Revision Number 1

MO – NW Pryor Rd. & Chipman – REVISION 1

REVISION 1 SET - ISSUED 07.07.2020

PROJECT NAME:
**BUILDOUT OF STARBUCKS
COFFEE - NW PRYOR RD &
CHIPMAN - LEE'S SUMMIT**

SHEET NUMBER:
G002

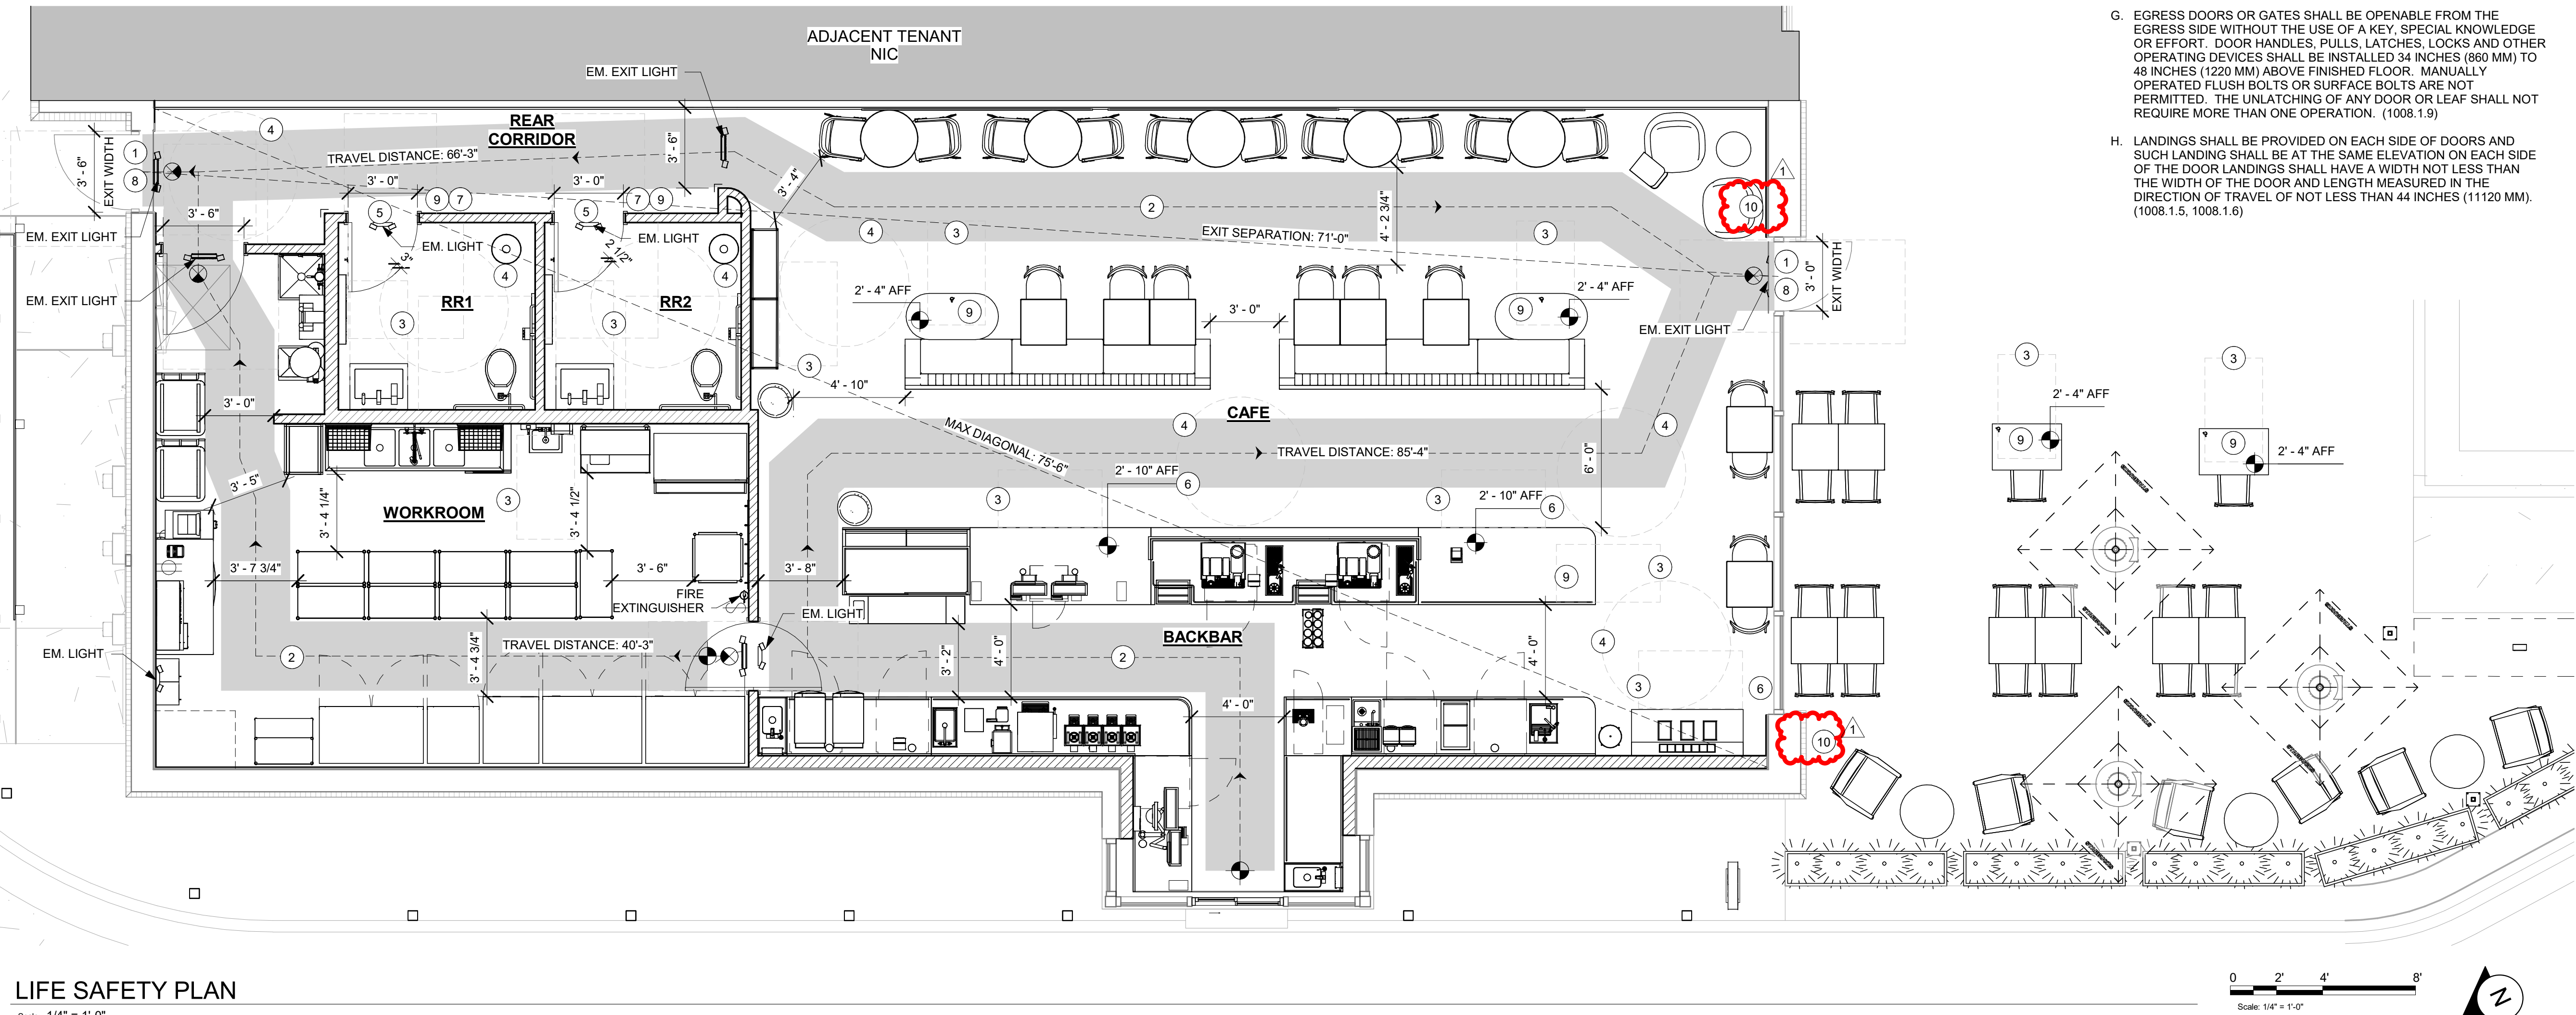
- Sheet G000 Sheet added to display scope of revisions, per Revision 1.
- Sheet G001 Sheet G000 was added to index.
- Sheet G002 Added and tagged key note 10, per Fire Department Comments.
- Sheet A201 Updated key note 1, per Fire Department Comments.
- Added and tagged occupancy sign in elevation #1, per Fire Department Comments.
- Sheet I101 Added and tagged occupancy sign in FF&E Plan, per Fire Department Comments.
- Sheet I202 Added and tagged occupancy sign in elevation #3, per Fire Department Comments.
- Sheet I601 Added occupancy signs to graphics & artwork schedule, per Fire Department Comments.
